Re: Case No. 22-549-EL-BGN

In the Matter of the Application of Oak Run Solar Project, LLC for a Certificate of Environmental Compatibility and Public Need to Construct a Solar-Powered Electric Generation Facility in Madison County, Ohio.

Response to Fifth Data Request from Staff of the Ohio Power Siting Board

**OAK RUN SOLAR PROJECT, LLC 'S
RESPONSE TO THE FIFTH DATA REQUEST
FROM THE STAFF OF THE OHIO POWER SITING BOARD**

Updated Figure 2.1

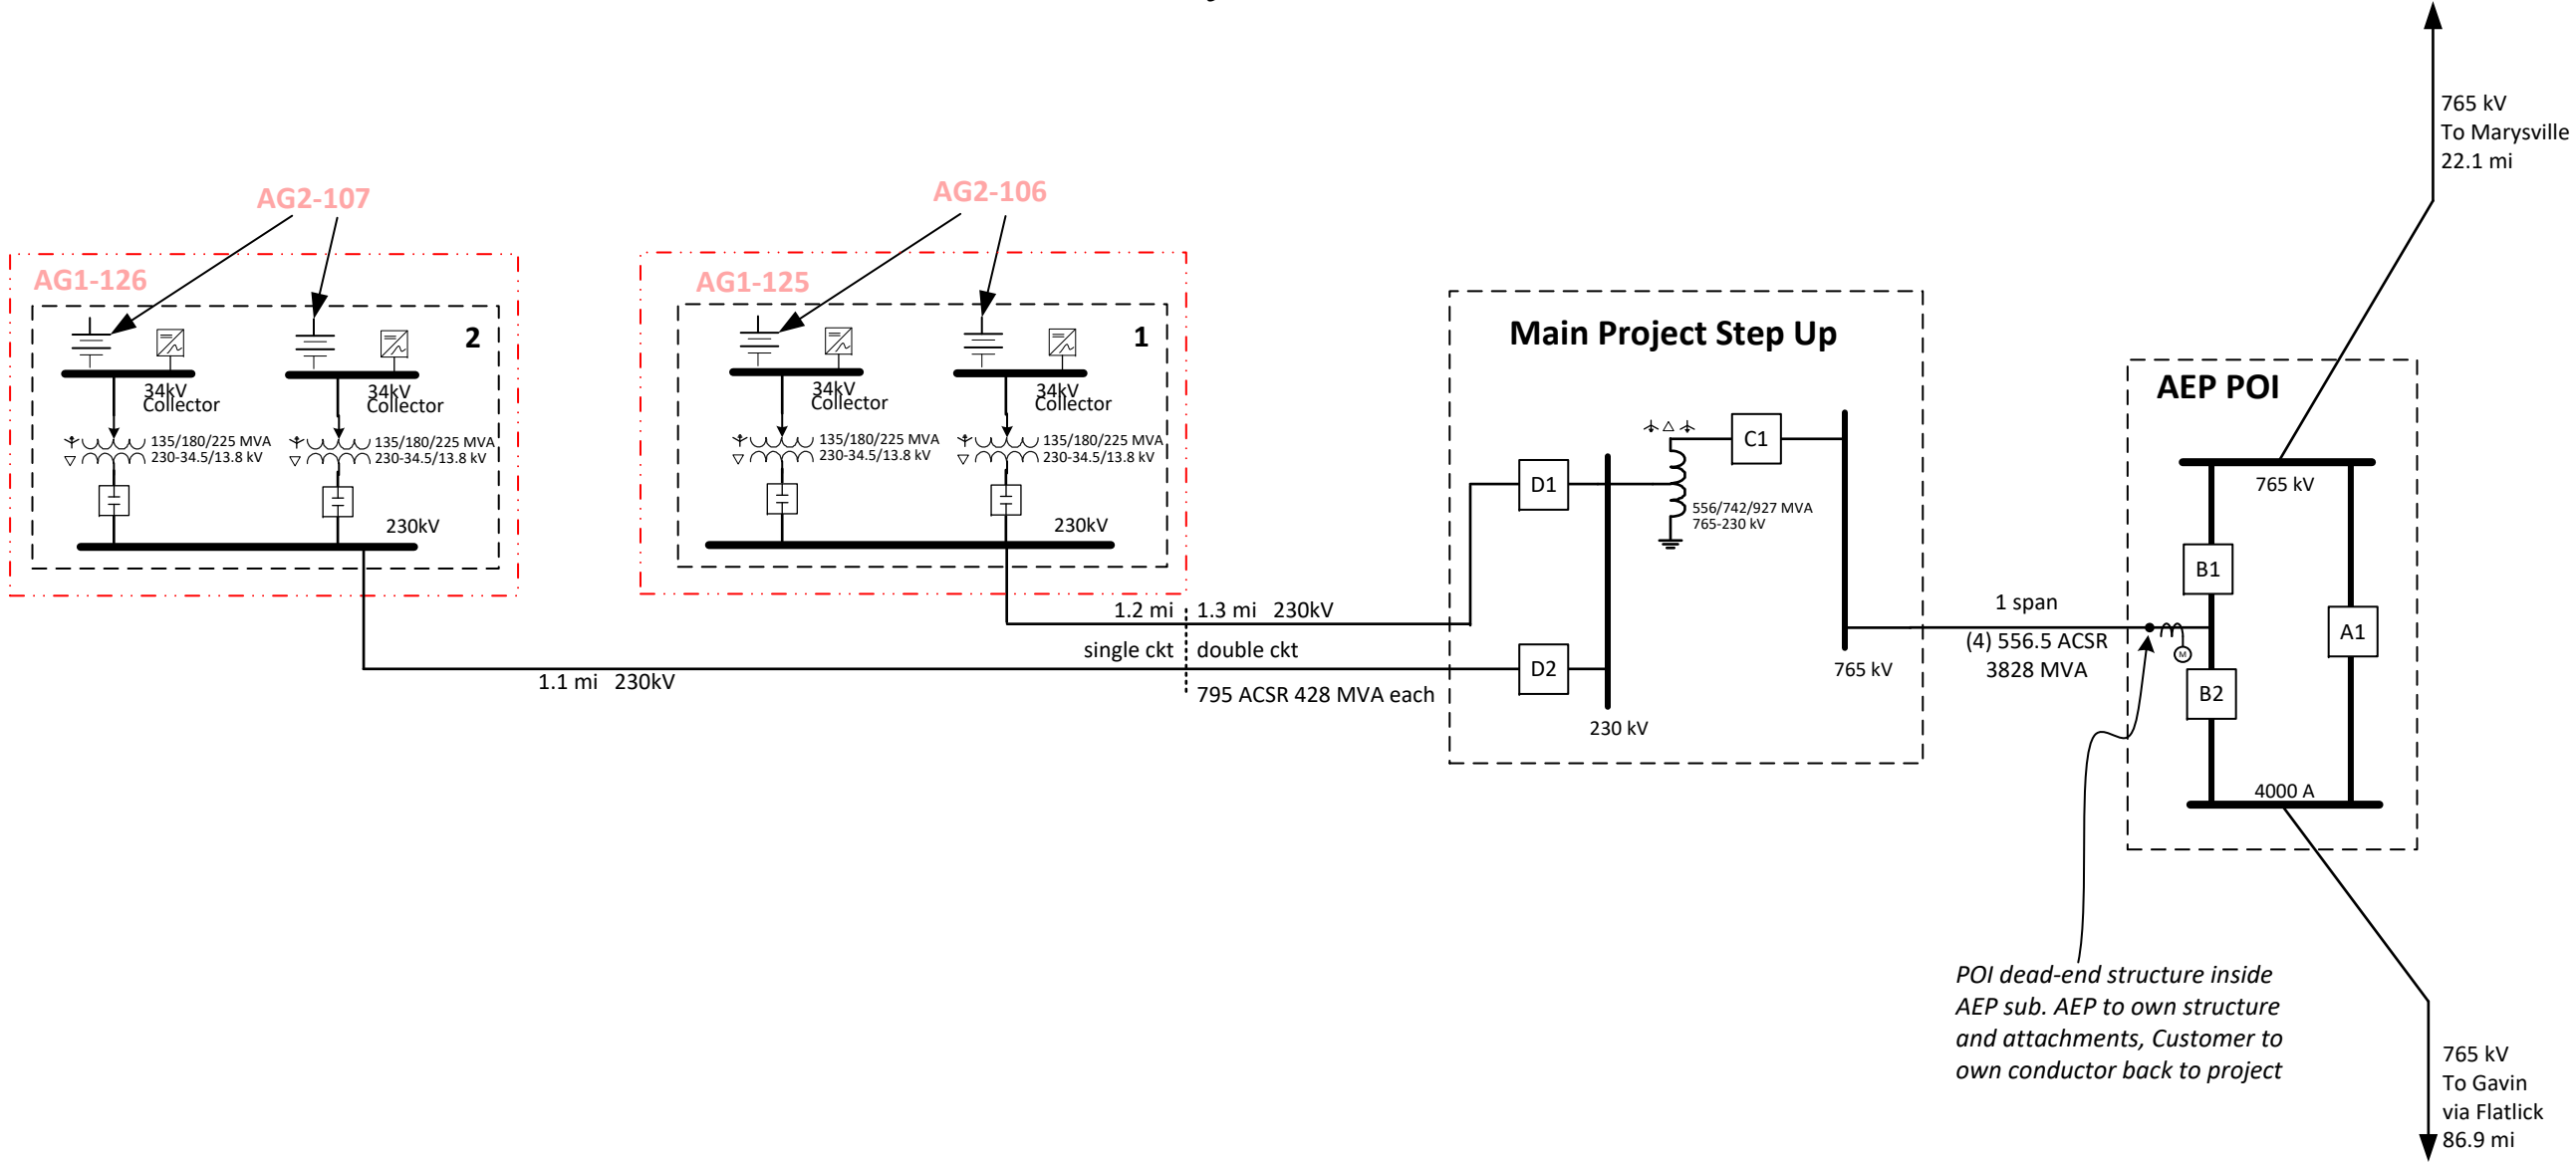
1. **What would be the lengths of each of the two 230-kV lines going from AG1-125 and from AG1-126 to the ‘Main Project Step-Up’ Transformer illustrated in Figure 2-1 of page 28/157?**

5. **Please explain or provide a calculation supporting the “857 MVA” and the “1914 MVA” on Figure 2-1, page 28/157 of the Application.**

Response: The conductor chosen for the 230 kV line was 795 Aluminum Conductor Steel Reinforced (“ACSR”) with a continuous operation limit of 1074 Amps. The Figure 2-1 diagram filed with the Application on September 2, 2022, indicates 857 megavolt-amperes (“MVA”) each, which is an error. It should say 857 MVA total, or 428 MVA each, which will be corrected on Figure 2-1.

$$1074 \text{ A} \times \sqrt{3} \times 230 \text{ kV} = 428 \text{ MVA.}$$

The 765 kV connection between the Project Step-up Station and point of interconnection (“POI”) Switchyard will be relatively short. The design limitation was voltage corona rather than thermal or cost. Voltage corona discharge contributes to losses, electromagnetic field (“EMF”) interference and the potential for making cracking or popping noises, which the Applicant is trying to avoid. Using a bundled conductor increases the conductor’s effective geometric mean radius and reduces the potential for ionization. The conductor for the segment was intended to be (4) 556.5 ACSR, but it looks like the Applicant’s consultant used (2) 556.5 ACSR. $2 \times 722\text{A} \times \sqrt{3} \times 765,000\text{V} = 1914 \text{ MVA}$, in the original figure included with the Application. Most of the 765 kV lines in Ohio use four-bundle conductors

and, given the common atmospheric conditions, that should be applied here as well. As such, the thermal rating for this span should be $2 \times 1914 = 3828$ MVA, which will be corrected on Figure 2-1.

These two corrections are included in the attached revised Figure 2.1. Figure 2.1 attached to this response replaces and supersedes Figure 2.1 submitted with the Application on September 2, 2022.
